CONSTRUCTION SUMMARY

Grovetrail Developments Inc.

LOT NUMBER	PHASE	HOUSE TYPE	CLOSING DATE
60 BLOCK 233	3	LAWSON Elev A1	20-Aug-25

OAKRIDGE
 MEADOWS

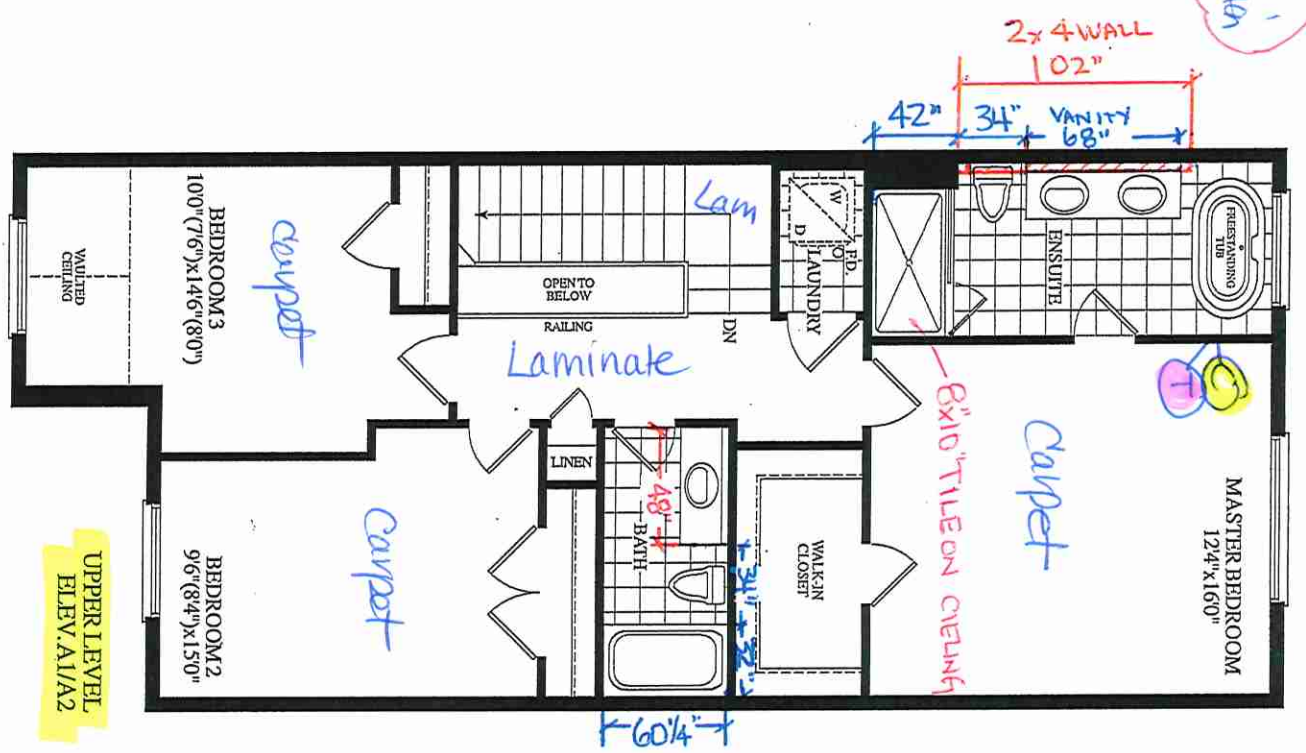
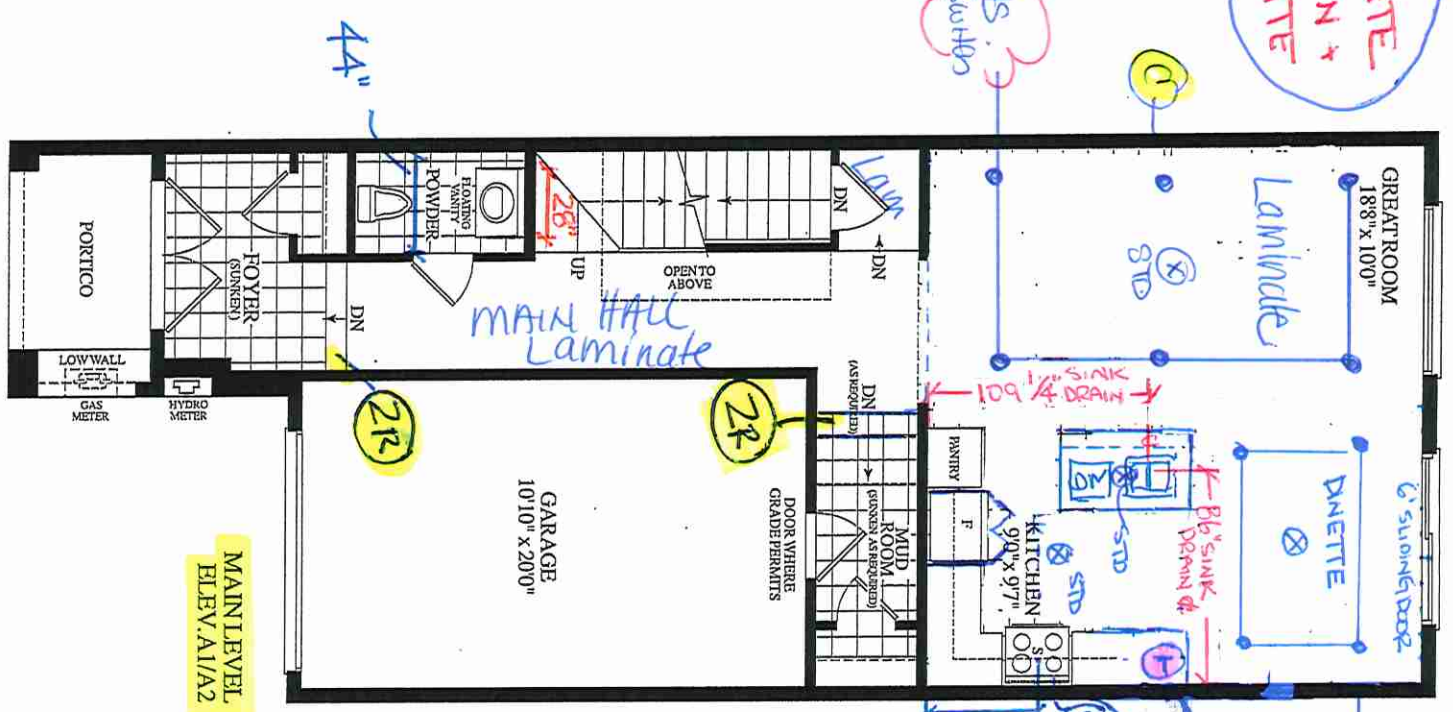
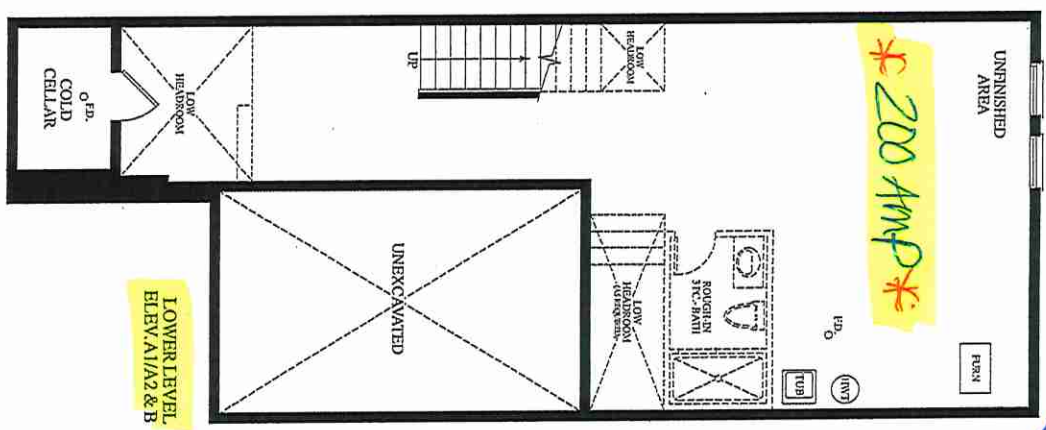
1 - GREAT ROOM- In addition to the builders standard ceiling light, Install SIX (X6) pot lights. All SIX (X6) pot lights to be on their own switch (See Sketch) Note:
1 - DINETTE- In addition to the builders standard ceiling light, Install FOUR (X4) pot lights. All FOUR (X4) pot lights to be on their own switch (See Sketch) Note: **PLEASE NOTE** charge for additional switch **PLEASE NOTE** Original builders standard ceiling light from original Dinette area to be installed at new Dinette area (See Sketch)
1 - PURCHASER AWARE AND ACCEPTS THAT ANY CHANGES MADE TO UPGRADES AFTER SIGNING THIS PURCHASERS EXTRA FORM ARE SUBJECT TO A MINIMUM ADMINISTRATION FEE OF \$1,000 Note:
1 - PURCHASER HAS ATTENDED A STRUCTURAL AND COLOUR CHART APPOINTMENT AT THE DESIGN STUDIO AND HAS DECLINED ANY ADDITIONAL UPGRADES Note:

1 - BASEMENT-Install 200Amp service in lieu of the standard Note:
1 - SECOND FLOOR-Install smooth ceilings throughout the 2nd floor, where applicable, in lieu of the standard (See Sketch) Note:
1 - KITCHEN- Install a Gas Line rough in for the stove (See Sketch) Note:
1 - KITCHEN- Re-configure kitchen layout Delete the peninsula and create an island. Original Dinette area to become part of the great room, and part of the great room to now become the Dinette area (See Sketch) Note: **Kitchen sink and dishwasher to be relocated to the island** **Kitchen layout to follow at time of colour chart
1 - PURCHASER AWARE AND ACCEPTS THAT ANY CHANGES MADE TO UPGRADES AFTER SIGNING THIS PURCHASERS EXTRA FORM ARE SUBJECT TO A MINIMUM ADMINISTRATION FEE OF \$1,000 Note:

* LAMINATE
 KITCHEN +
 DINETTE

6 POTS
 1 SP. SUTON

4 POTS
 1 SP. SUTON

* 2ND FLOOR SMOOTH CEILING *

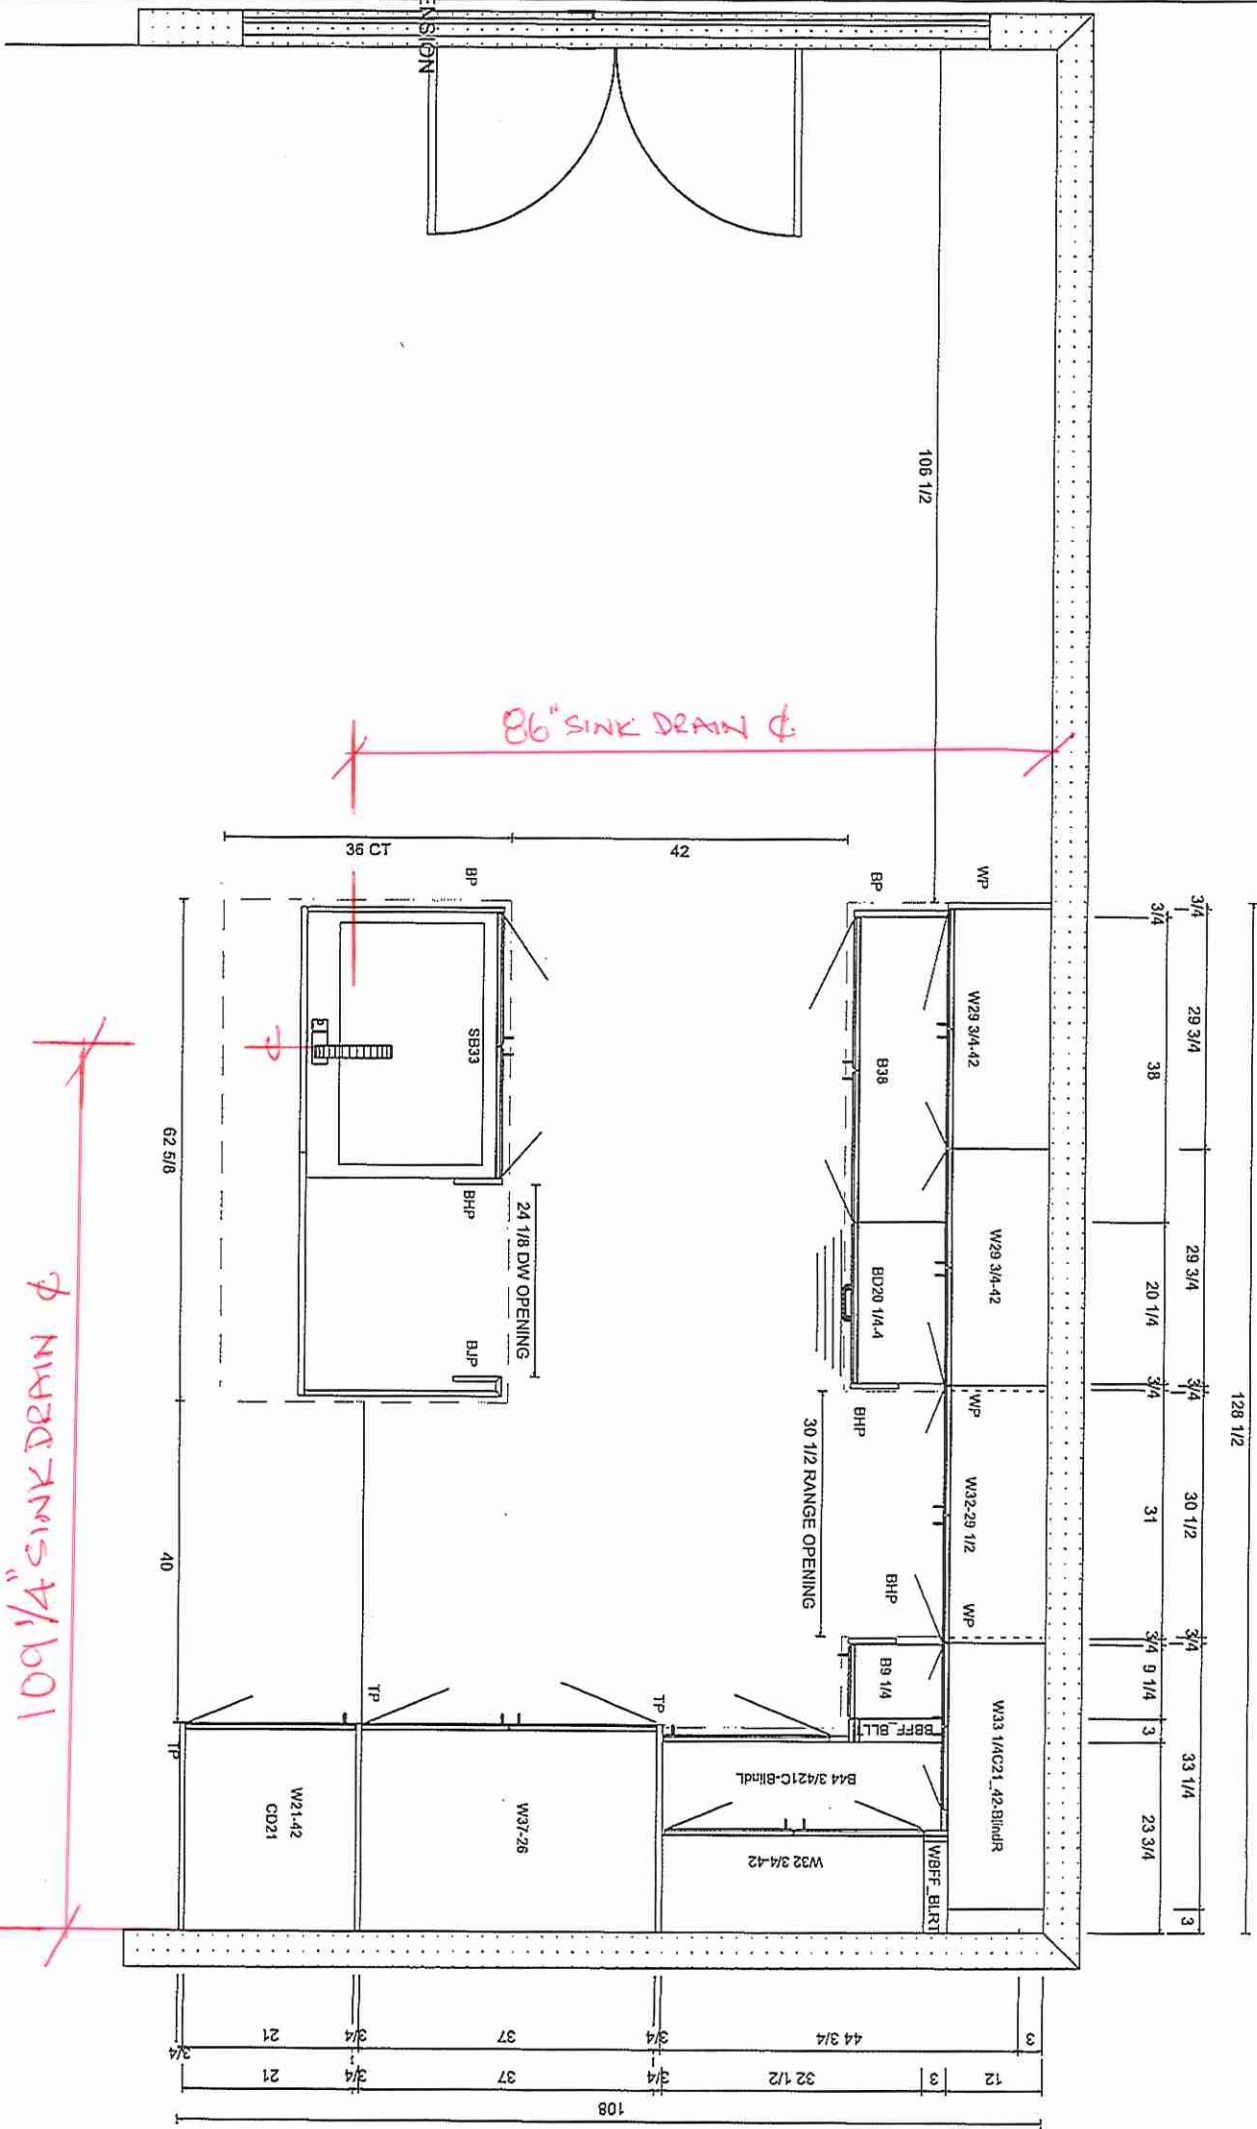
1 - KITCHEN- Install deep upper fridge cabinets above fridge with applicable gables (See Sketch)

1 - KITCHEN- Install additional extended uppers (as required), base cabientry and additional builders standard counter top on the stove wall. To be inline with the island (See Sketch)
